CONTRACT No. 50-3871-D

FRIENDSHIP LAKE SHARED SEPTIC SYSTEM

THIRD ELECTION DISTRICT HOWARD COUNTY, MARYLAND

TITLE SHEET; INDEX OF DRAWINGS, GENERAL NOTES,

₹900 GALLON SEPTIC TANK-PLAN

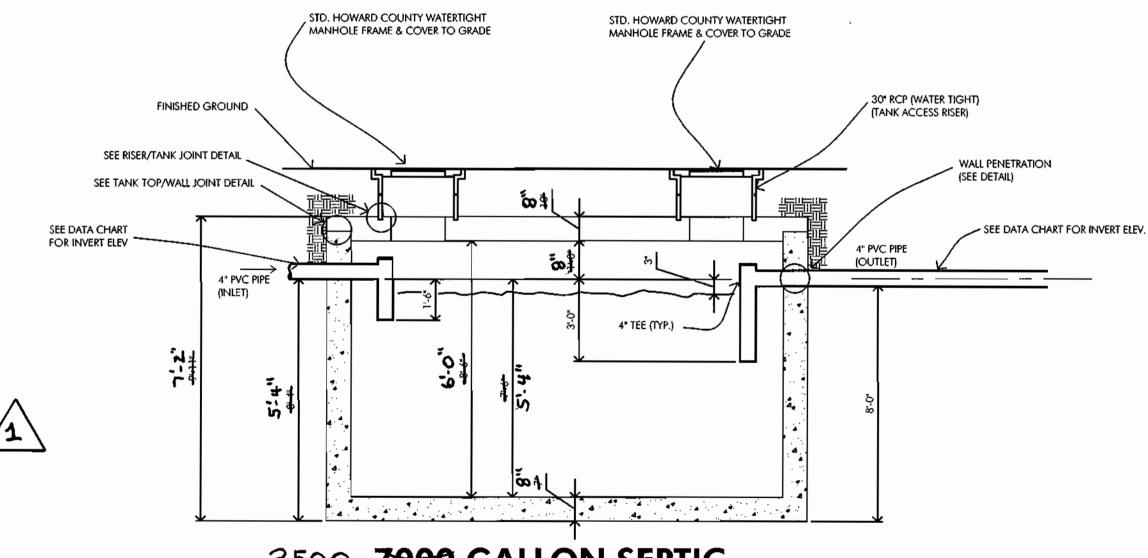
3,500

3,500 **Zee GALLON SEPTIC**TANK-SECTION

OJL.	4.	ADD 2×3500 GAL SEPTIL TANKS		
\setminus	DES: R.SELL					
-)	DRN: RIR					
	DRN: RJR					
/	CHK: R.SELL					
100	•					
۱"	DATE: 1/00	BY	No.	REVISION	DATE
